Appendix A: PROPOSED PROVISIONS IN TRACKED CHANGES – Whiskey Creek Private Plan Change

This document sets out amendments to the District Plan provisions proposed in the Whiskey Creek Private Plan Change request and recommended in the body of the s42A report.

Plan Change request to insert – Map 7A.3.

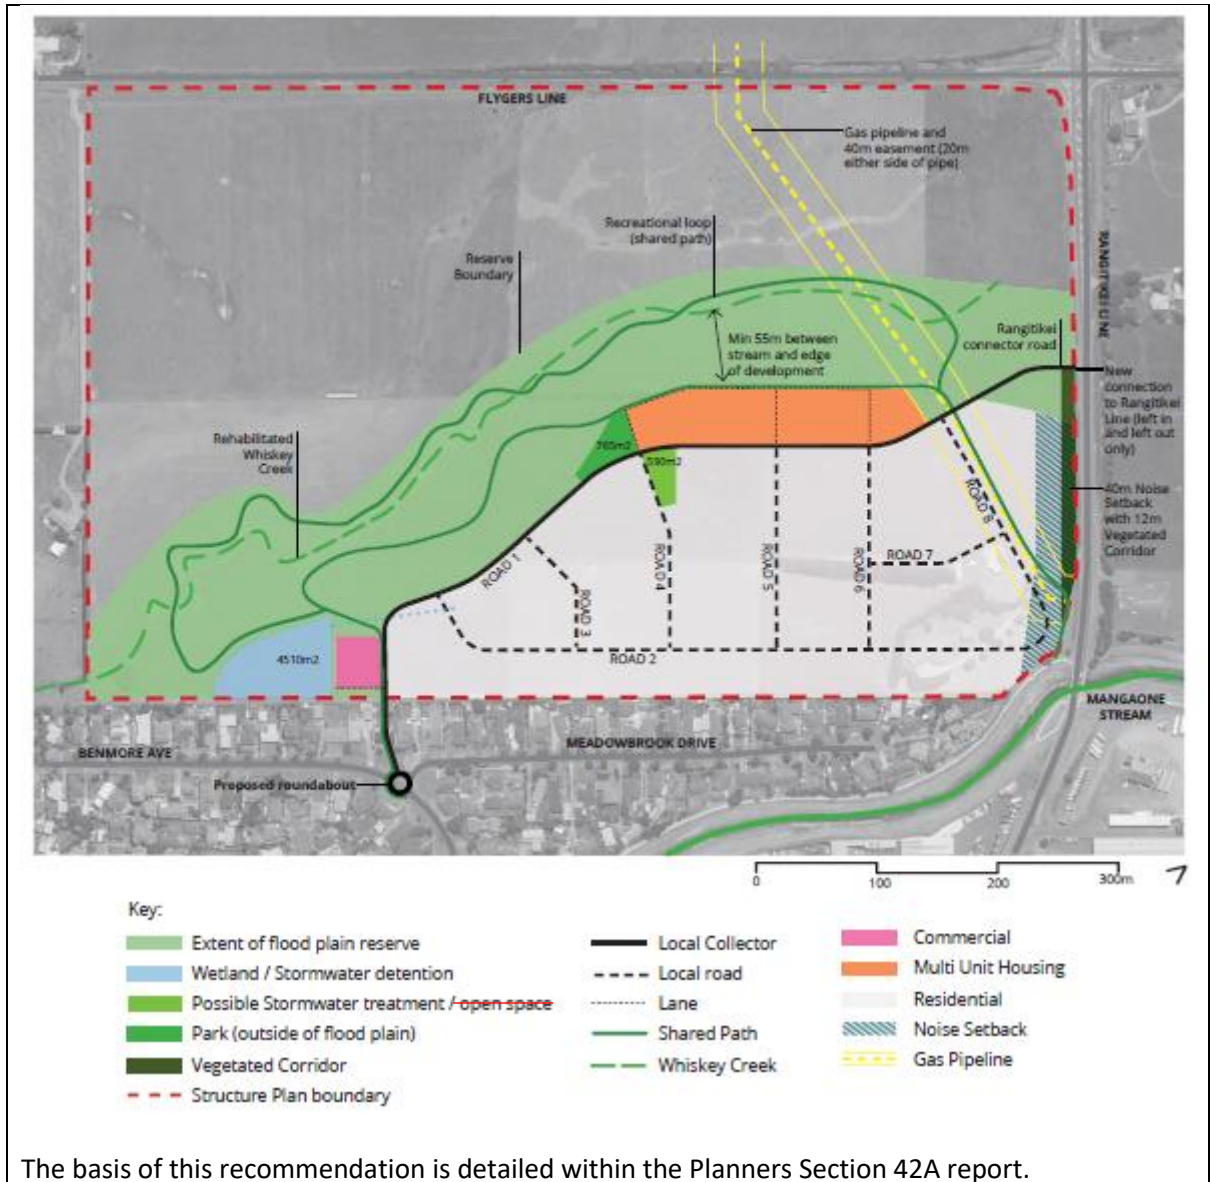
The Planners s42A report recommends that this request is amended as detailed below.

Following amendments are recommended:

- *remove references to Open Space/ Parks or Recreation functions from any stormwater treatment reserves.*
